SERVICE BULLETIN

Feb. 15, 2000

**FOR ALL BASS
FISHING U/R
GAMES**

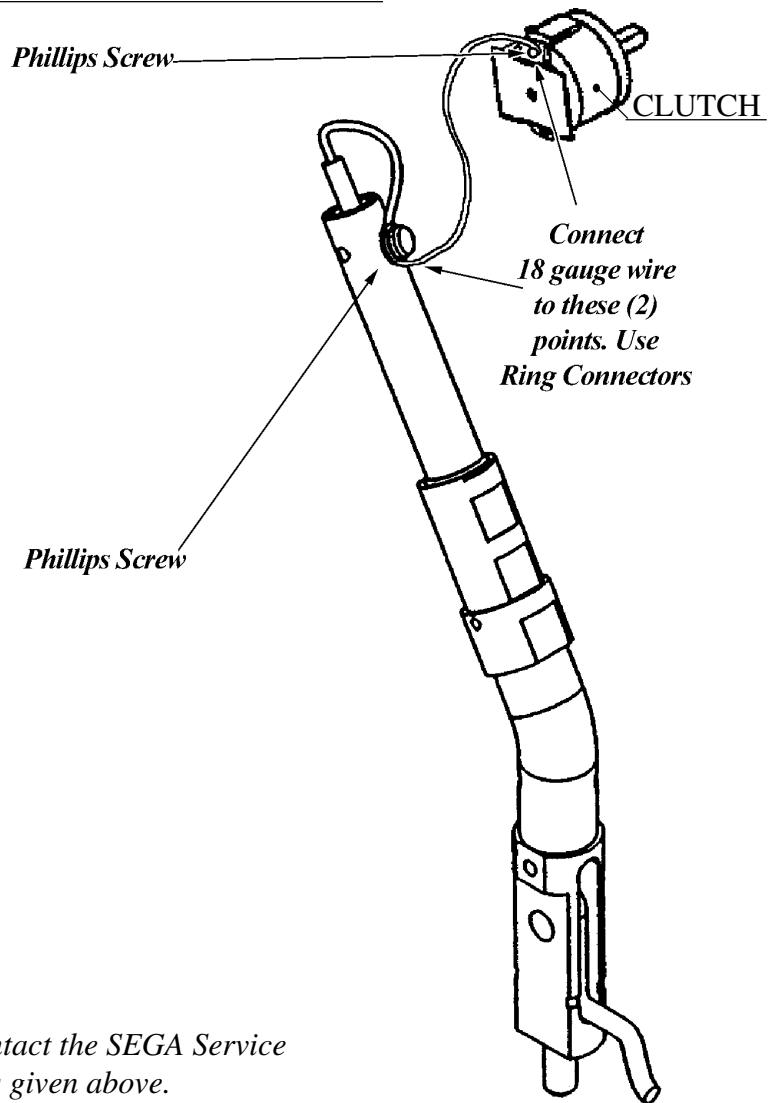
Problem: Reel encoder becomes disfunctional.

Cause: Excessive static being discharged into control handle can damage encoder.

Solution: To help control this, a second ground wire (18 guage) can be added to the handle assy (see diagram below) . Also, the use of an extension cord for main power should be avoided. The outlet that the machine is plugged into needs to be properly grounded, use Recepticle (plug polarity) Tester to verify. (Grainger Part No. 3T885) *or equivalent.*
